Re: Northfield Mountain Pumped Storage Project, FERC Project No. 2485

FirstLight Submittal of Information Concerning Request for Noise Study

Appeal to Rejection of Proposed Northfield Mountain Noise Study L. McLoughlin / W. Ondras June 12, 2013

Persistent 42 Hz Tone - Closer

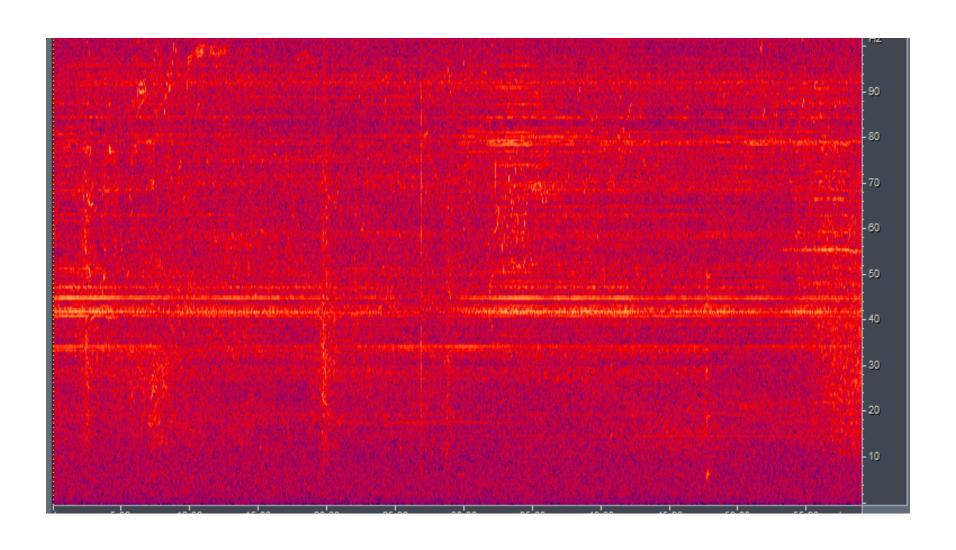
I reviewed the power point presentation from L. McLoughlin and W. Ondras dated June 12, 2013. I have not noticed any significant vibration at 42 Hz in generate and 42 Hz does not lineup with any rotating component frequencies at Northfield Mountain.

Persistent 42 Hz Tone
